COACHMEN RV GROUP

RE: Safety Recall 07V-483

Coachmen RV Company has decided that a defect which relates to motor vehicle safety exists in 2006 Aurora Motorhomes, model numbers 3180DS, 3480DS, 3580TS and 3650TS. These vehicles were manufactured at Coachmen RV's Middlebury, Indiana facility from November 9, 2005 through May 2, 2006.

EXAMPLES OF SYSTEMS NEEDED TO BE REPLACED

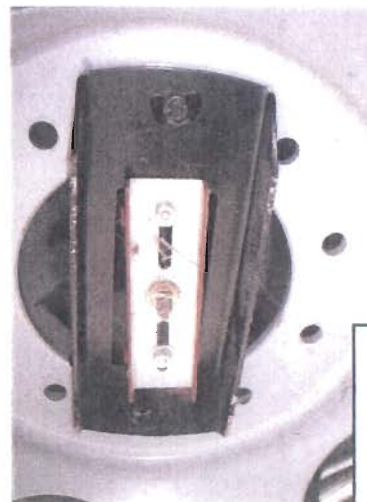
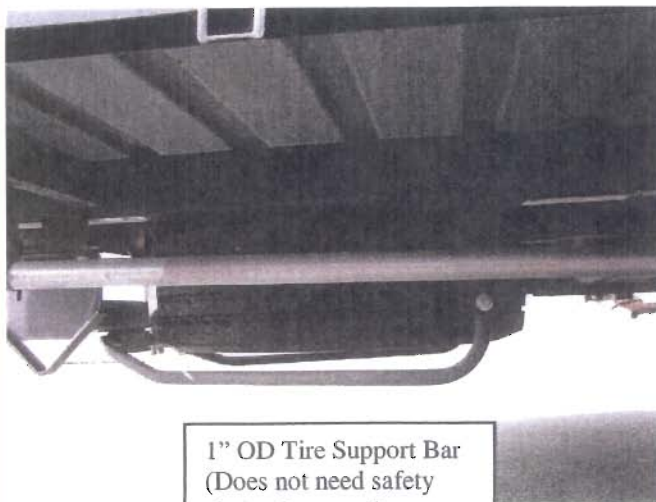
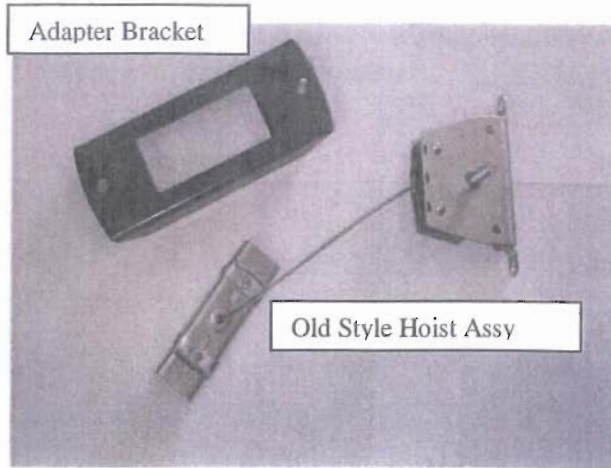
BAD – MUST BE REPLACED WITH NEW WINCH ASSY & SAFETY CHAIN & CONNECTING LINK
 *All system types ***must*** have the Hoist Assembly replaced and if no secondary safety device is provided, you must install the Safety Chain with Connecting Link. ** If your particular system is not shown, replace the Hoist & add Safety Chain or call the number at the end of this bulletin for assistance. **

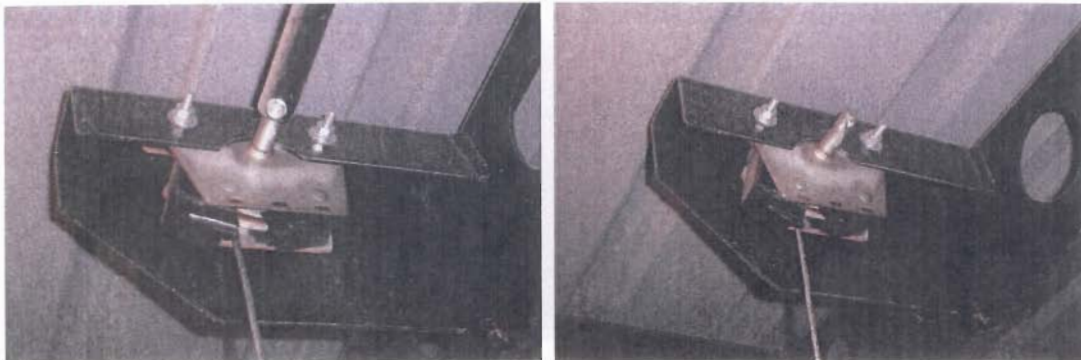
STEP 1 : Remove original spare tire from under your vehicle.

STEP 2 : Remove the pin or bolt which attaches the spare tire hoist mechanism with the crank tube.

STEP 3 : Remove the spare tire hoist mechanism which is held in place with two to four 1/4" bolts.

STEP 4: Install the new spare tire hoist mechanism into the existing mounting location using the 1/4" bolts, ensure proper tightening of fasteners.

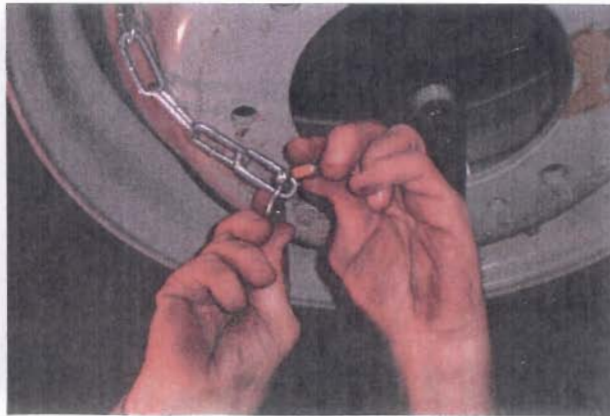
STEP 5: Rout safety chain through the one of the top mounting bolts, be sure to center the bolt with the fender washer on the chain links.

STEP 10: Thread one end of safety chain through center hole next to the lift plate bracket and the other end around the outside of the tire and join together with supplied connecting link.
(If your vehicle has the 1" diameter Spare Tire Support Bar installed you will not have to use the Safety Chain & Connecting Link).
